# CITY OF ALBUQUERQUE

**Re:    Mountain Mahogany Community School PH II, 5014 4<sup>th</sup> St NW,  
Request for Permanent C.O. –Accepted  
Engineer's Stamp dated: 03-01-12, (F14/D062)  
Certification dated: 07-12-12**

**Re: Mountain Mahogany Community School, 5014 4<sup>th</sup> Street NW**  
**Grading and Drainage Plan**  
**Engineer's Stamp date 3-01-12 (F14/D062)**

**Re: Mountain Mahogany Community School, 5014 4<sup>th</sup> Street NW, Grading and Drainage Plan**

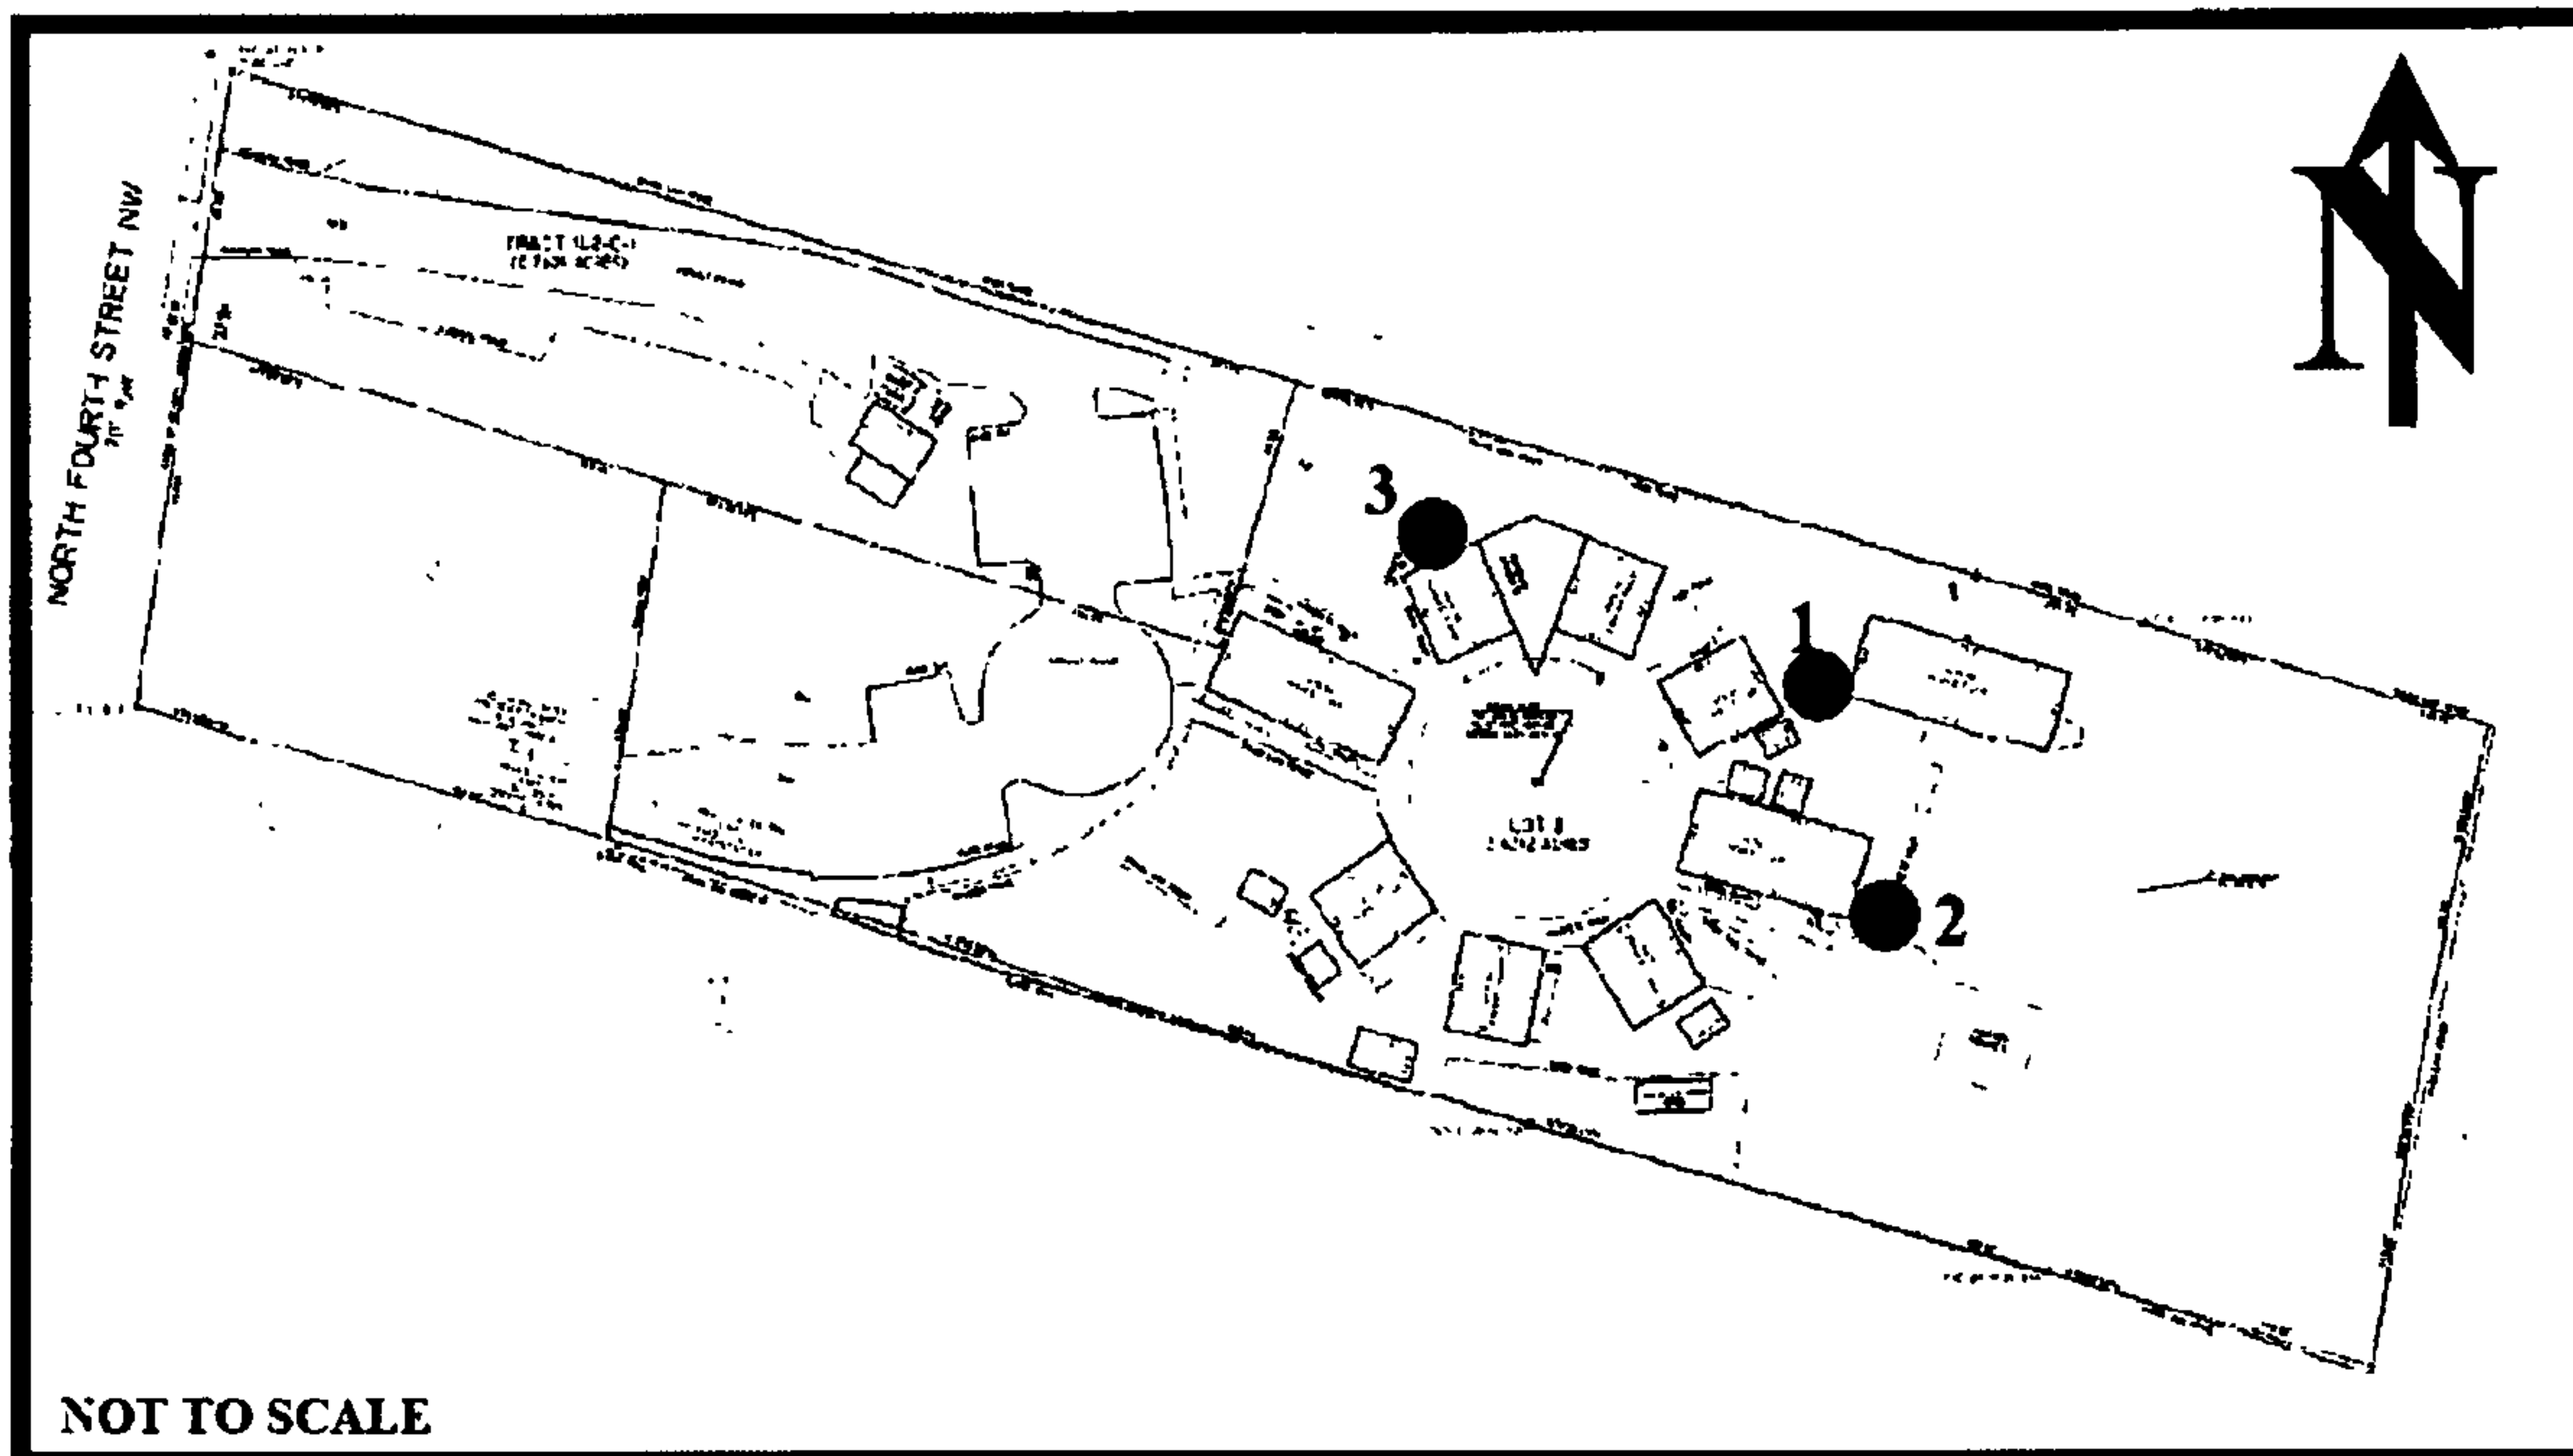
- An approved Grading and Drainage plan is on file for this property and the proposed grading appears to impact the on-site retention ponds that were approved to contain the 100 yr, 10 day storm event.
- One of the existing structures was previously built without a permit and encroaches on one of the approved retention ponds.
- The proposed structures also appear to encroach on another on-site retention pond.
- Provide pond volume calculations to ensure proper water retention is maintained.

Site pond depths were calculated using Civil 3D as follows. A surface was generated based on the provided topographic survey. A second surface (a level plane) was generated to represent water surface elevation and moved vertically until the required volume was achieved. See the attached Volume maps for the portions of ponding .

Existing Conditions (32.8% impervious):  
Required 100-year 10-day volume = 22,535 CF = 835 CY  
Water Surface Elevation = 4972.4

In conclusion, the Mountain Mahogany Charter School site, based on existing topographic survey information, has volume available to store the 100-year 10-day storm event for the proposed condition as well as future additions shown. All of the existing and proposed buildings are elevated at least 2.0' above the future condition water surface elevation of 4972.7.
